# Chip Errata for the MPC8280 PowerQUICC II Family

This document describes all known silicon errata for the MPC8280 PowerQUICC II family of integrated communications processors. See [Table 2](#) for a list of devices.

Figure 1. Power Supply Ramping

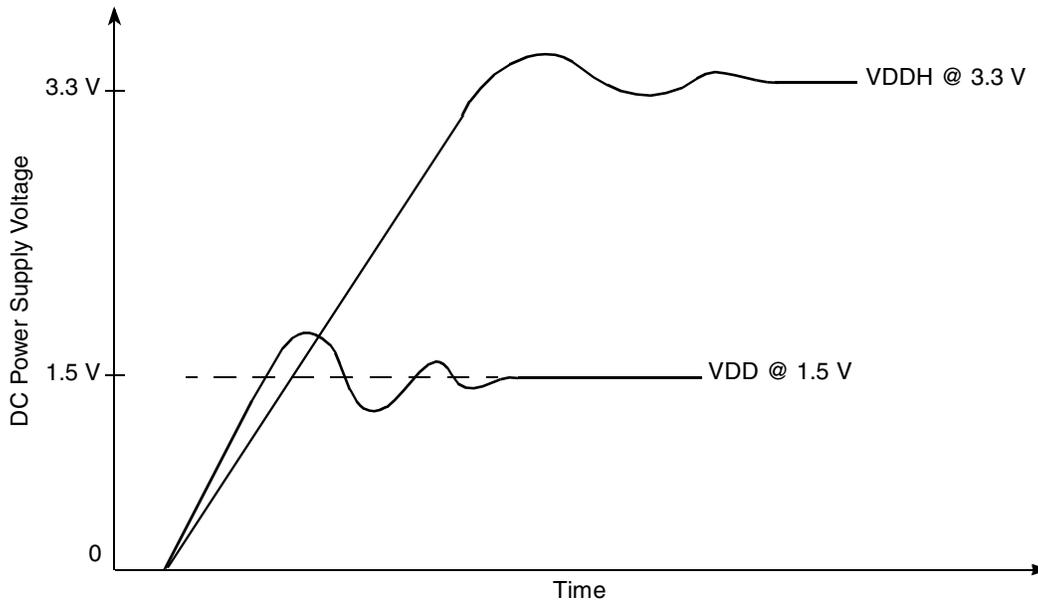
If core supply voltage (VDD) is below recommended operating conditions while I/O supply voltage (VDDH) is high during a power-on reset sequence, I/O pins (including those designated input only) might drive a value instead of being Hi-Z. This could confuse connected devices and, in turn, cause the PowerQUICC II device to behave improperly. Affected pins include such interfaces as the communication parallel I/O, reset, address and data bus pins, and JTAG pins. The value a pin may drive is random. As soon as core voltage has stabilized at its nominal level within recommended operating conditions, all pins will behave normally and the PowerQUICC II will continue to function properly.

It is recommended that VDD/VCCSYN be raised before or simultaneously with VDDH during the power-on reset sequence; that is, while  $VDDH \leq$  recommended operating condition for VDD/VCCSYN during ramp of all voltages, it should be ensured that  $VDD/VCCSYN \geq VDDH$  at all times. Refer to [Figure 1](#).

If the power supply design cannot be altered as recommended, then any logic connected to the PowerQUICC II which may react or be affected in an undesirable manner by unexpected low or high signal values during power ramp up should be appropriately secured in the design. Using

SDRAM as an example, it is usually sufficient to connect the CKE input to  $\overline{\text{PORESET}}$ . The practice of tying CKE high may not be safe and may lead to an unrecoverable system state.

**Figure 2. COP Connections to PowerQUICC II Processors**

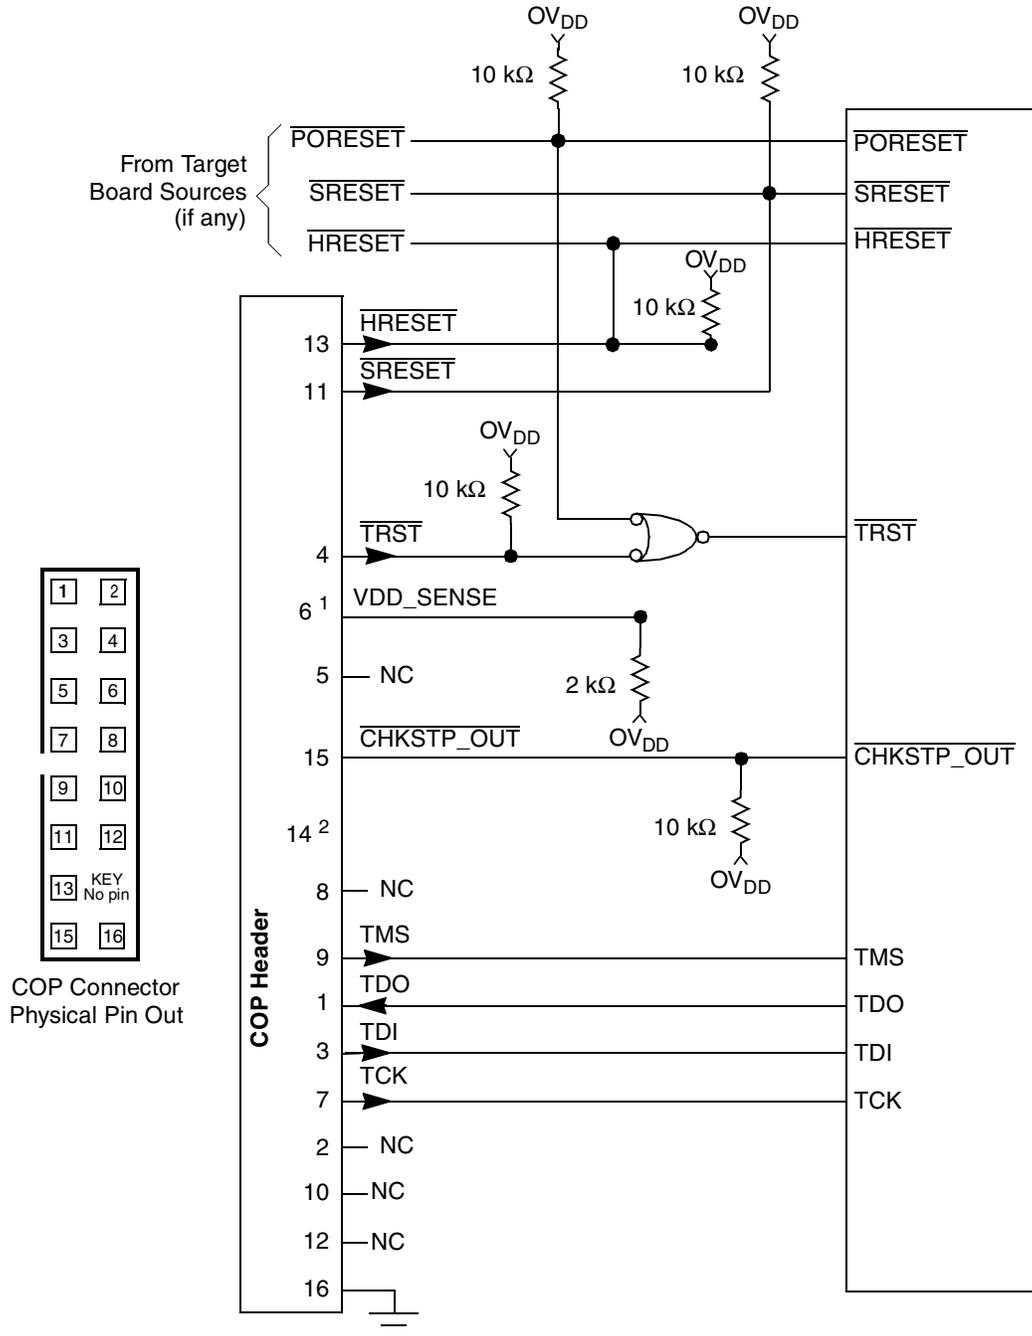
$\overline{\text{PORESET}}$  does not reset the CPU JTAG machine and, therefore,  $\overline{\text{TRST}}$  must be asserted during  $\overline{\text{PORESET}}$  in order for the CPU to work correctly.

For boards that require debugging capability, implement an external circuit as shown in [Figure 2](#).

1. Some systems require power to be fed from the application board into the debugger repeater card via the COP header. The resistor value for VDD\_SENSE is around 20 Ω.
2. Key location; pin 14 is not physically present on the COP header.

Figure 3. Transmit Timing for Cell-Level Handshake

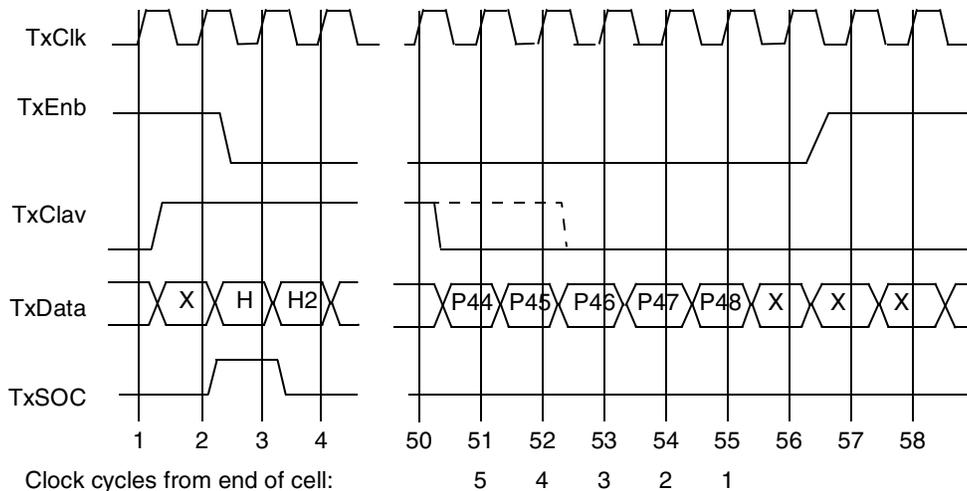
FCC ATM receive UTOPIA slave mode. When the RxFIFO is full, RxClav is negated 2 cycles before the end of the cell transfer instead of 4. A master that polls RxClav or pauses 3 or 4 cycles before the end of the cell transfer may sample a false RxClav and an overrun condition may occur. The dashed line in the timing diagram below depicts the actual RxClav negation (2 cycles before the end of the cell transfer instead of 4 cycles). The signals in the timing diagram are with respect to the master, hence, Tx interface is shown.

- Master should not poll RxClav or pause cell transfer at 4 cycles before the end of cell transfer. Master should poll 2 cycles before the end of the current cell or later. This can be achieved by introducing a cell-to-cell polling (and transfer) delay, which is equal or larger then one cell transfer time. If this can be achieved, the impact on performance is minimal.
- Configuring ATM only on FCC1 and setting FPSMR[TPRI] ensures highest priority to FCC1 Rx. In addition, for CPM utilization lower then 80% (as reported by the CPM performance tool based on UTOPIA maximal bus rate) the CPM performance is enough to guarantee that the RxFIFO does not fill up.
